Proposed Revisions to a Standard Plans Index

Index Number: 521-611

Index Title: Concrete Barrier/Junction Slab - Wall Coping (FRP)

TYPICAL SECTION THRU PRECAST 36" SINGLE-SLOPE
CONCRETE BARRIER AND COPING WITH C-I-P JUNCTION SLAB

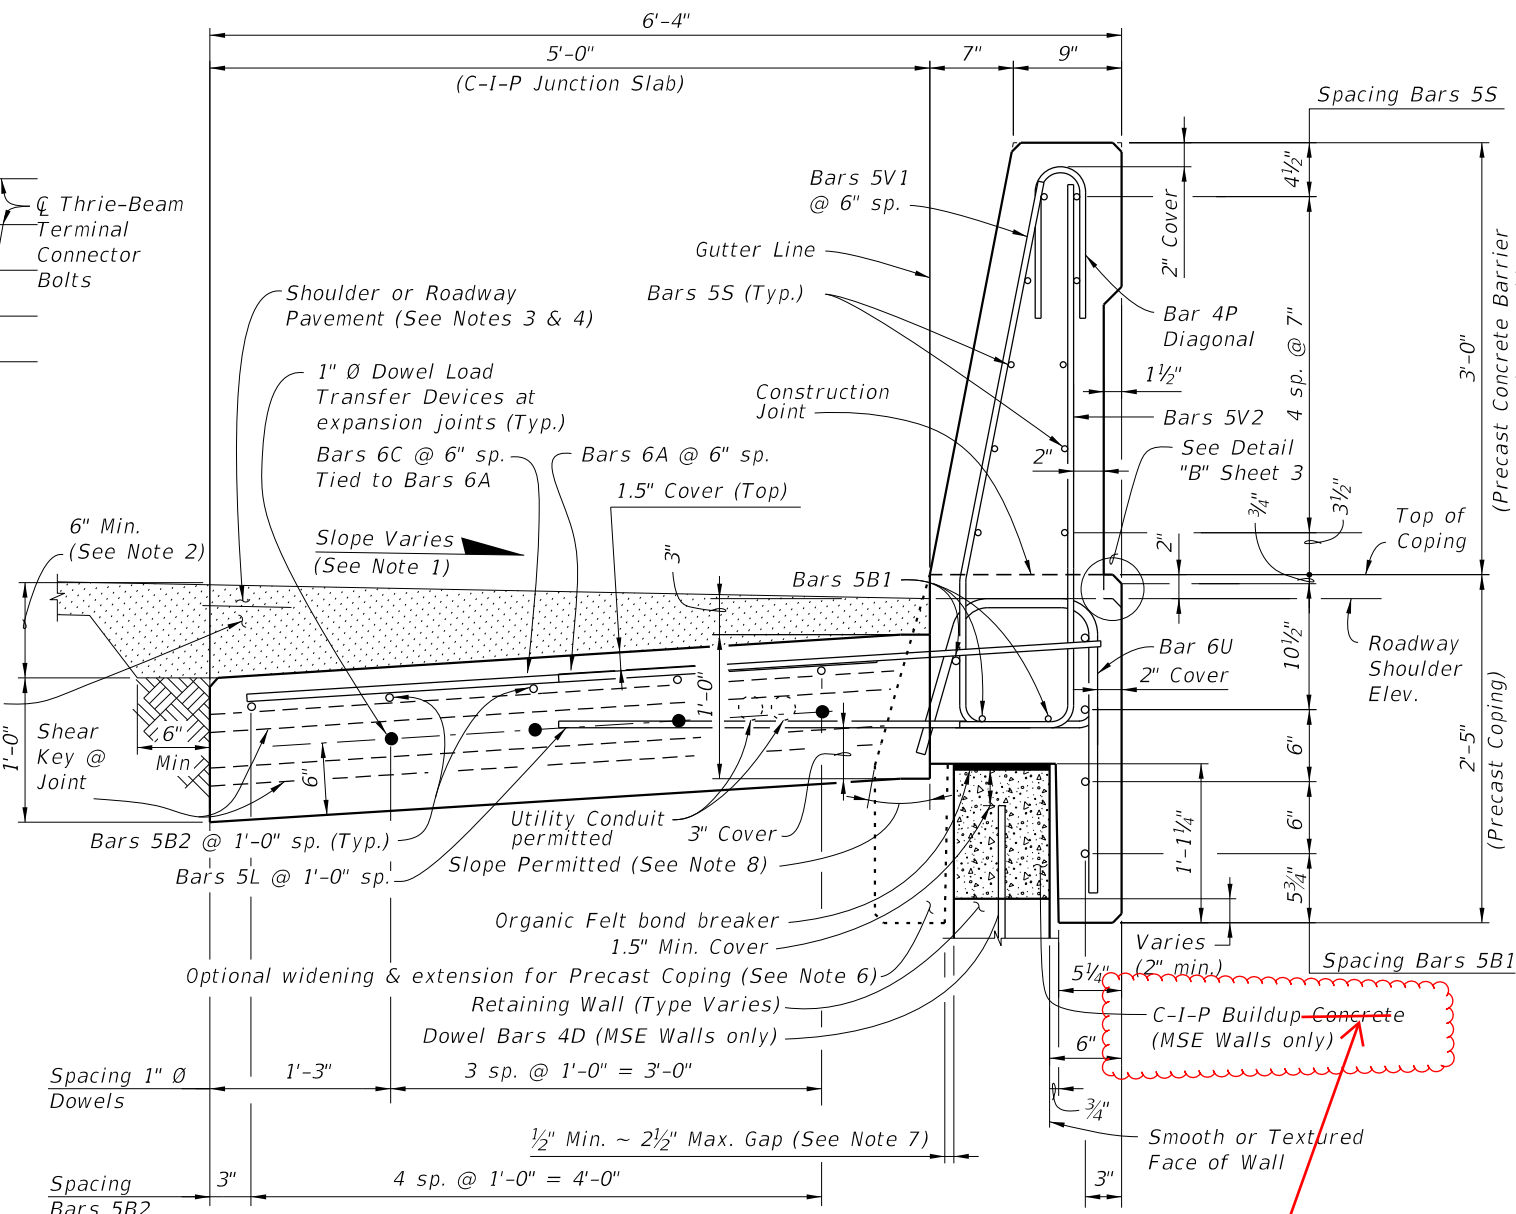
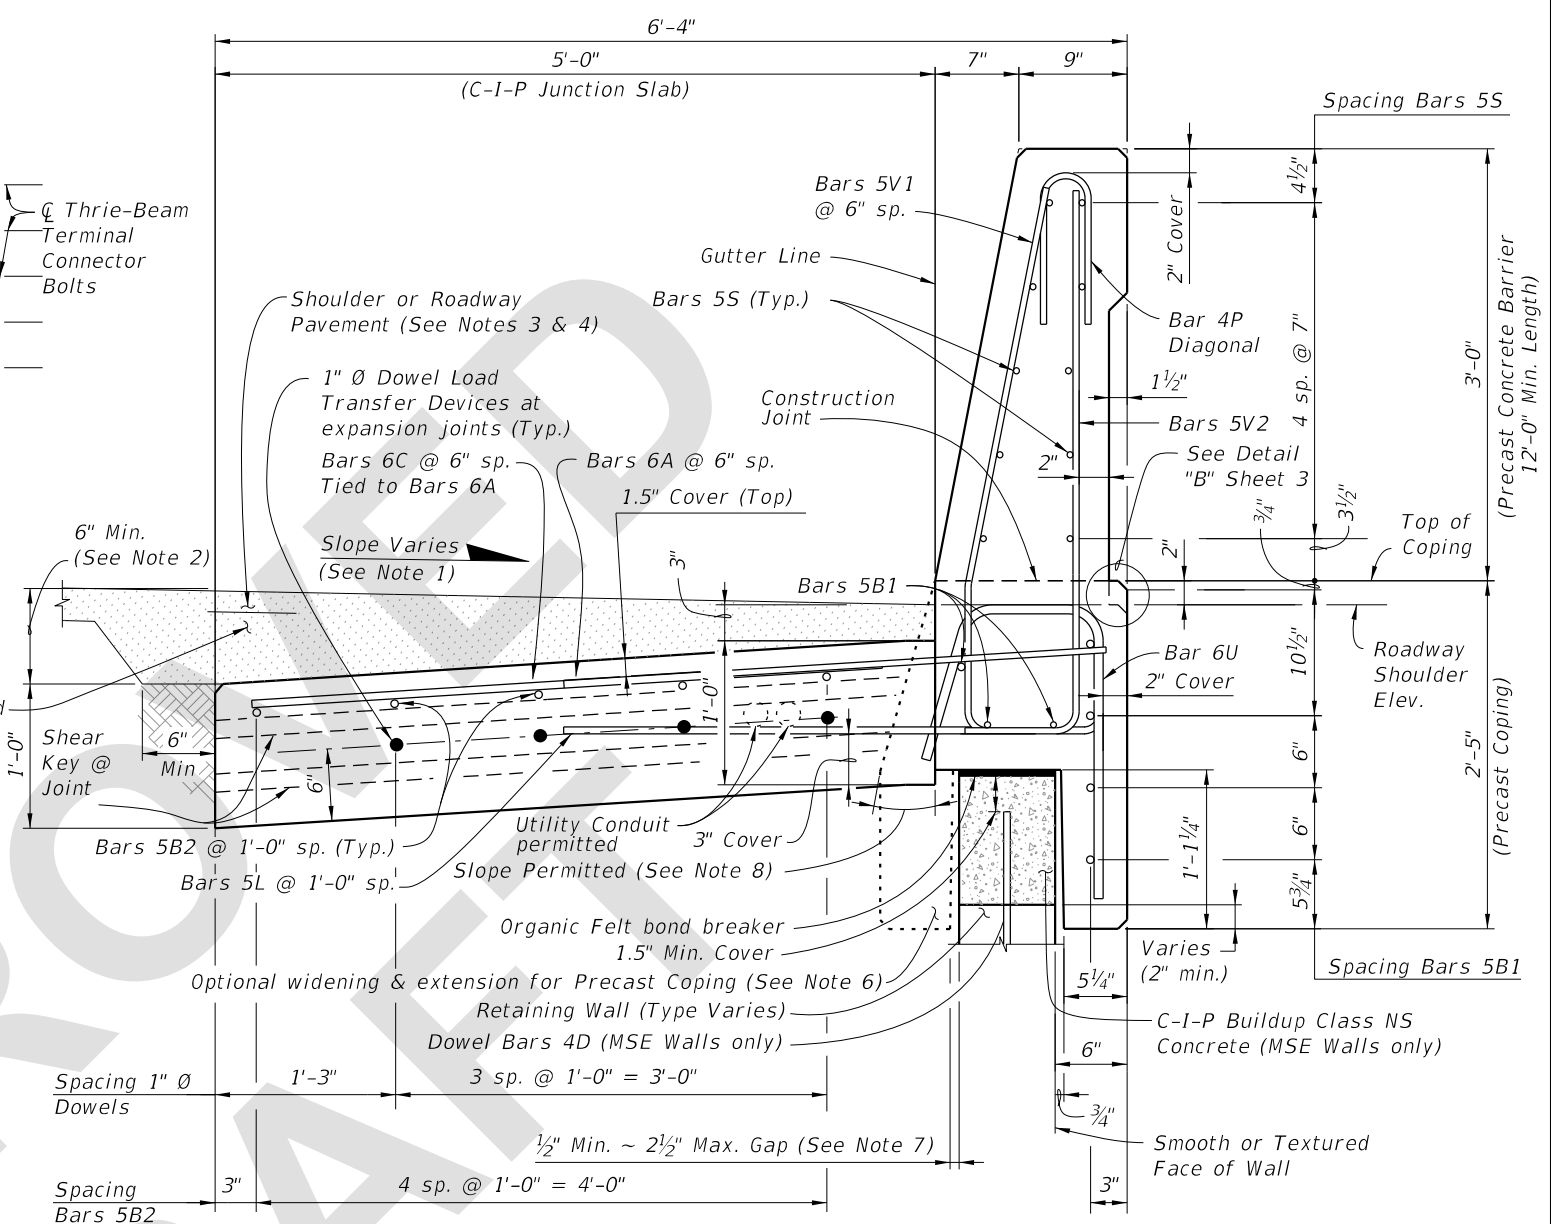
Changed C-I-P Buildup Concrete (1'-1" Max.) callout in the TYPICAL SECTION THRU PRECAST 36" SINGLE-SLOPE CONCRETE BARRIER AND COPING WITH C-I-P JUNCTION SLAB to C-I-P to Class NS Concrete (1'-1" Max.).

CIP buildup concrete type was never clarified. SDO review deems Class NS is acceptable because the concrete buildup section is not meant to transfer any meaningful load to the wall other than self weight.

CHANGED TO: Class NS Concrete
